**FINAL DRAFT
TECHNICAL MEMORANDUM NO. 1**

**ADDENDUM TO FINAL PHASE I
RFI/RI WORK PLAN**

Revised Network Design -- Field Sampling Plan

Rocky Flats Plant
Woman Creek Priority Drainage

Proposed Location of Shallow Wellpoint Monitoring Sites
 Woman Creek Drainage Basin

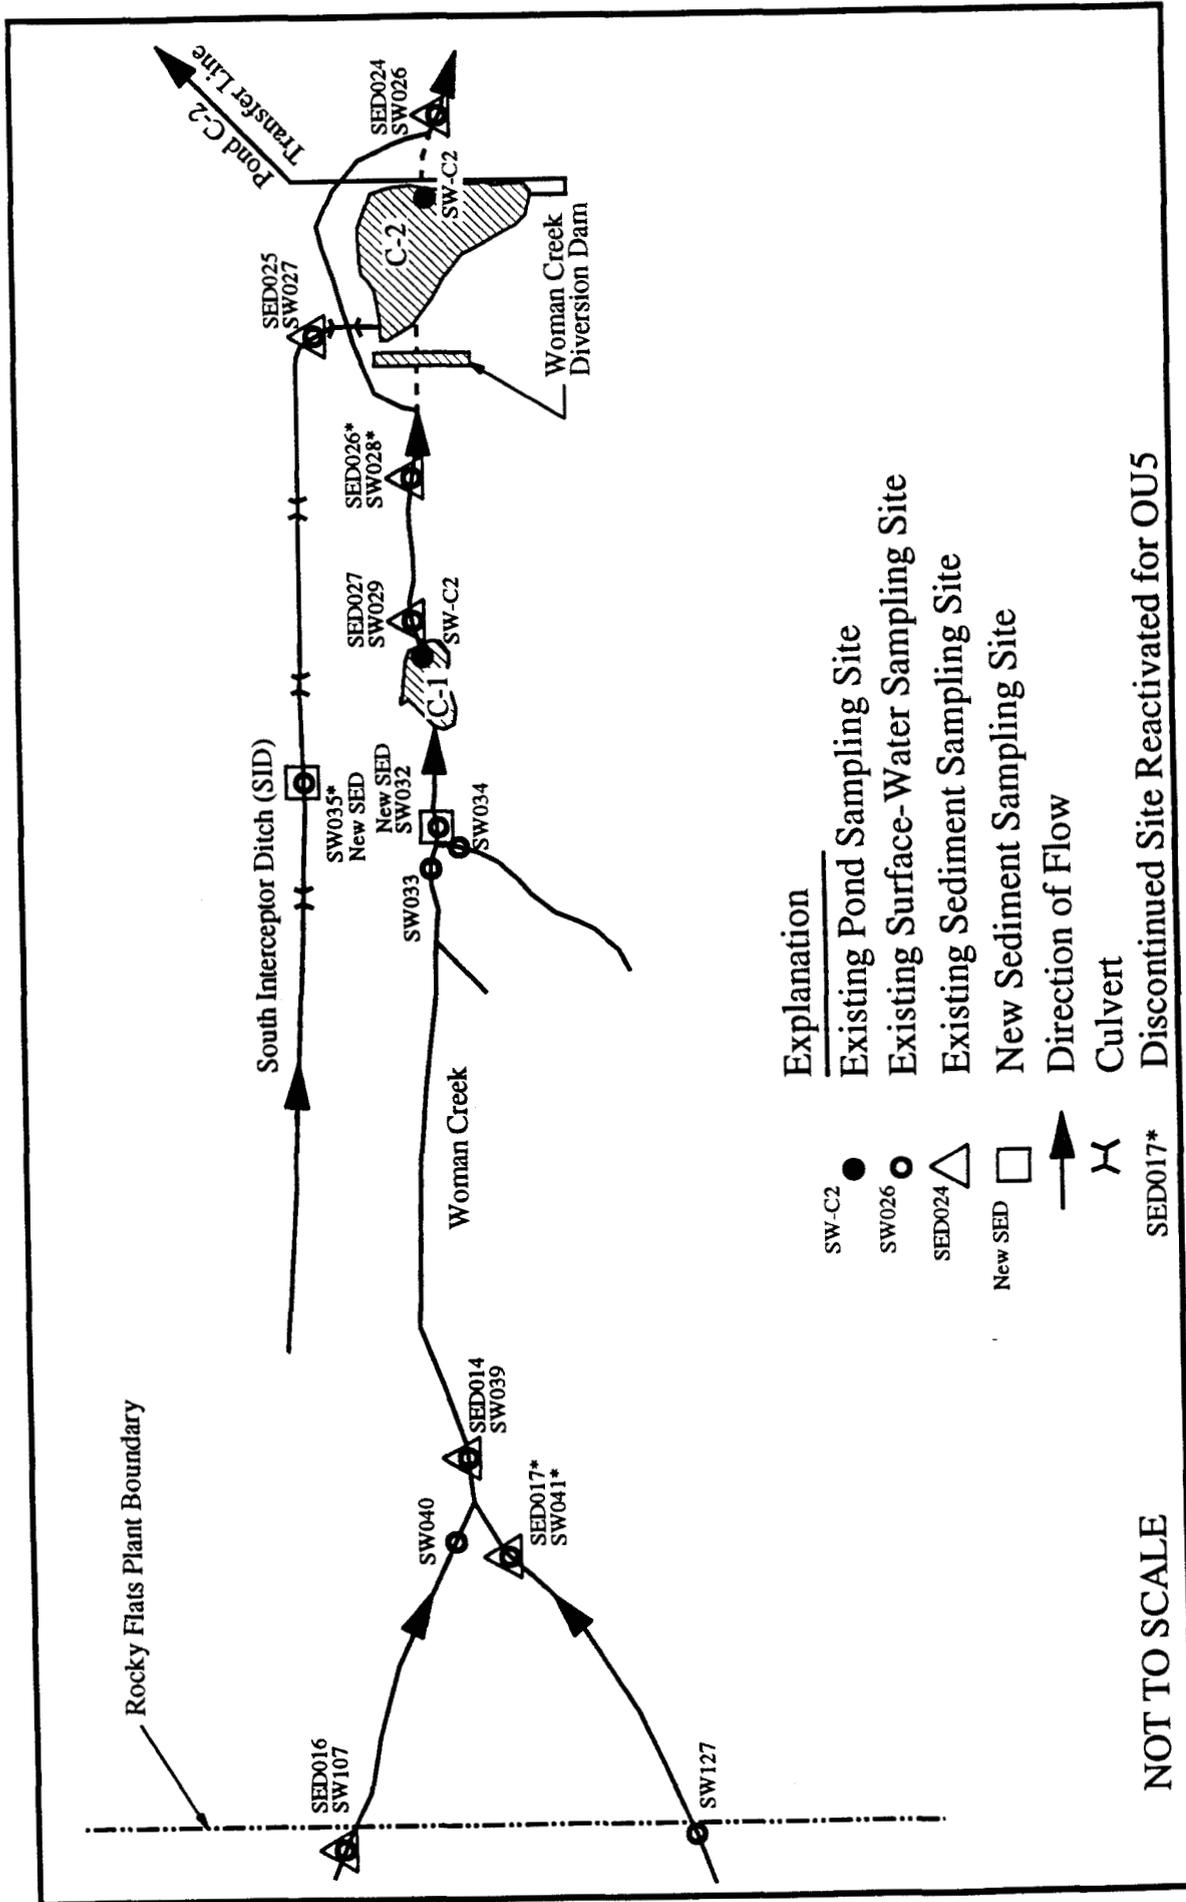
materials, the number and location of the monitoring locations shown on Figure 7 may vary. Only water levels would be measured in these pipes. In addition to pipes along Woman Creek to establish if the alluvial water levels are above or below the stream bottom, three additional lines of pipe would be installed perpendicular to Woman Creek (Figure 7). These three lines of pipe would include (1) a line from Woman Creek north toward the ash pits; (2) a line from Woman Creek north to the SID near Antelope Spring; and (3) a line from Woman Creek north to the SID between Pond C-1 and Pond C-2 diversion (Figure 7). These lines would help establish if a continuous ground-water connection exists between Woman Creek and these locations. Each wellpoint or pipe would be surveyed to establish its reference elevation relative to the stream channel bottom and/or water surface. The water-level elevation in each well point and in Woman Creek would be measured monthly at the time of the gain/loss study. These shallow alluvial well data would confirm if the surface water measurements are occurring in or near a gaining or losing reach based upon ground-water measurements. These data would be used to help calibrate both the ground-water and surface-water models and provide an assessment of the potential for contaminants to move between the shallow ground-water and surface-water systems.

- The existing WET-test program underway for the C-ponds will be sufficient to provide toxicity data.
- Ground-water/surface-water interaction data collection currently ongoing by EG&G and CSU should be augmented by several lines of wellpoints or driven pipes to measure the elevation of the shallow alluvial water table near Woman Creek to confirm gaining and losing reaches.
